Statement of Response to ABP's Opinion

**Proposed Residential Development,
Ballymany,
Newbridge,
Co. Kildare**

The pre-application consultation Opinion from An Bord Pleanála in relation to the proposed strategic housing development at Ballymany, Newbridge, Co. Kildare was received on the 23rd December 2020, case reference: ABP-308498-20.

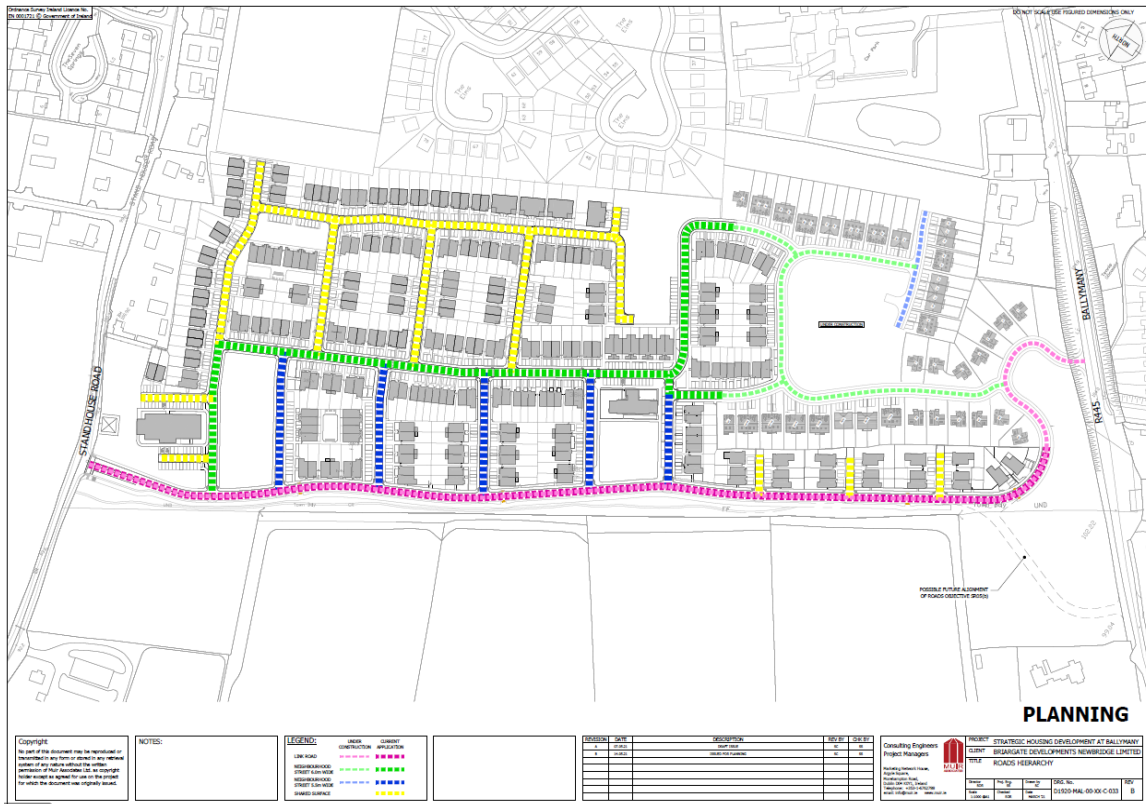
- 5. Further consideration / amendment of the proposed hierarchy of streets within the scheme, including the provision of homezones to ensure that through traffic is directed towards the distributor road and not through the scheme.**

The MAL drawing below shows a clear strategy for a roads and streets hierarchy (Dwg Ref. D1920-MAL-00-XX-C-033). The main link road runs externally along the western edge and discourages through-traffic. A central 6m carriageway spine route facilitates internal car traffic and feeds out to the link road. The homezone network is traffic calmed with reduced speed limit to create safe neighbourhoods

of distinct character with pedestrian and residents safety at the forefront, while the materiality of these streets allow for wayfinding and definition.
